1 REQ'D AS DRAWN MK: BM12

ISSUES BM12-01 / 02 / 03 | CENTRAL AWNING NODE

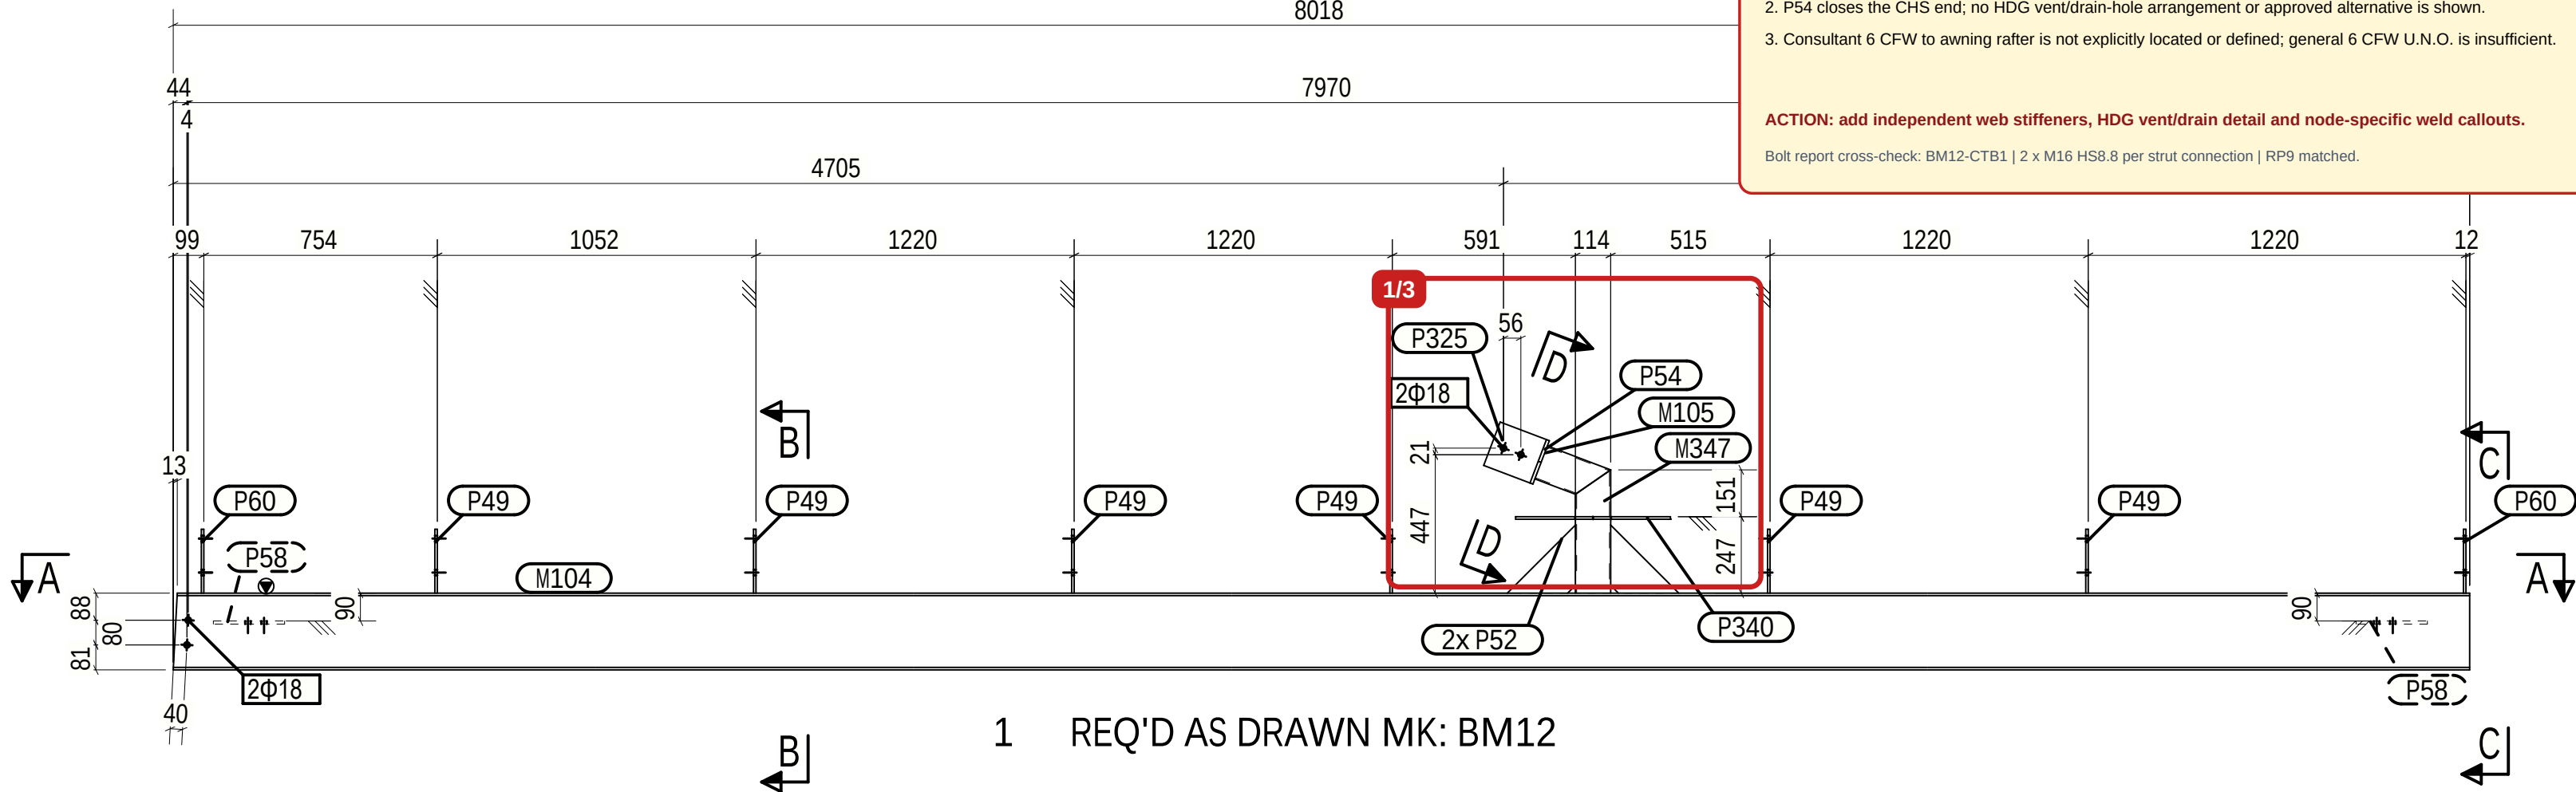
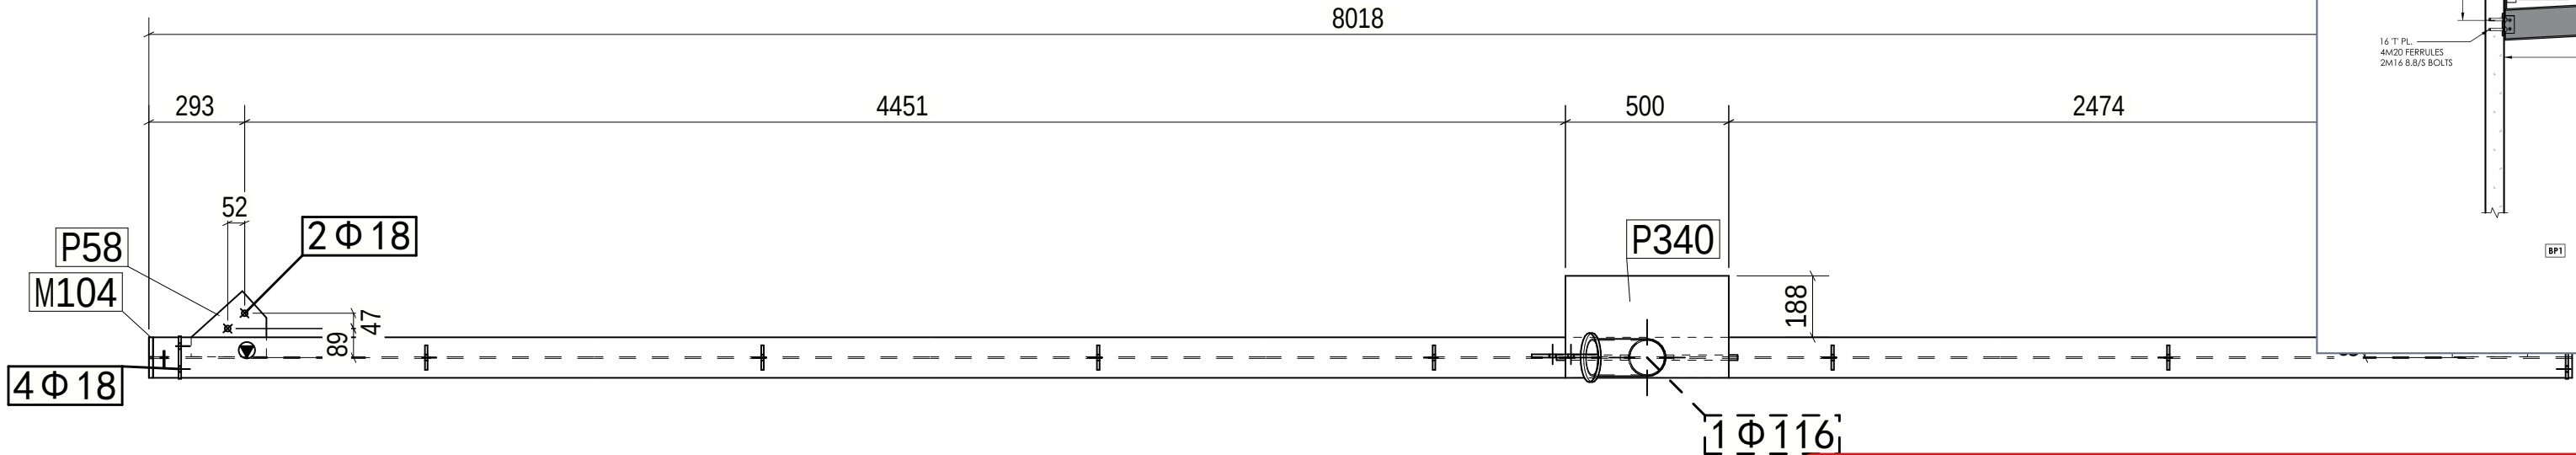
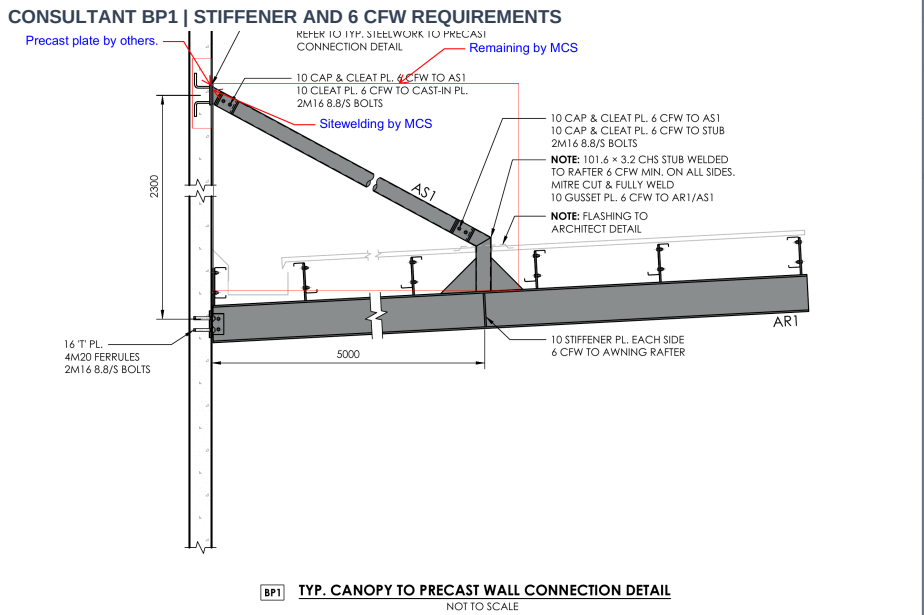
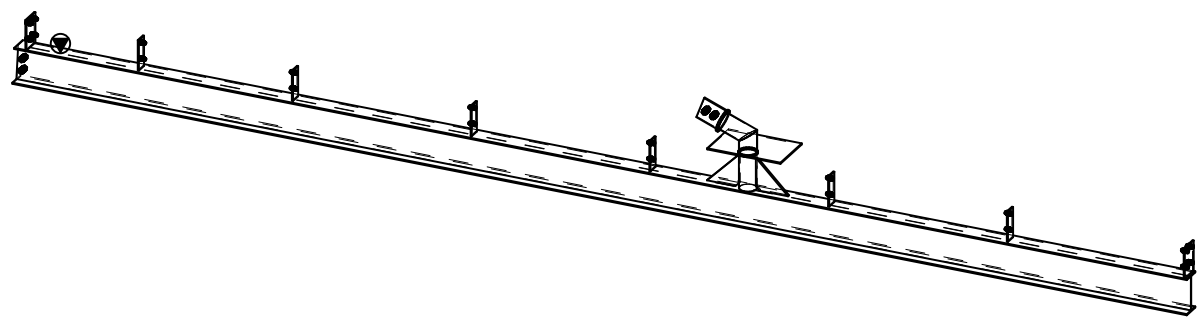
- 1. 10 mm stiffener plate EACH SIDE of the M104 web is not separately detailed; P52 is not the required stiffener.
- 2. P54 closes the CHS end; no HDG vent/drain-hole arrangement or approved alternative is shown.
- 3. Consultant 6 CFW to awning rafter is not explicitly located or defined; general 6 CFW U.N.O. is insufficient.

ACTION: add independent web stiffeners, HDG vent/drain detail and node-specific weld callouts.
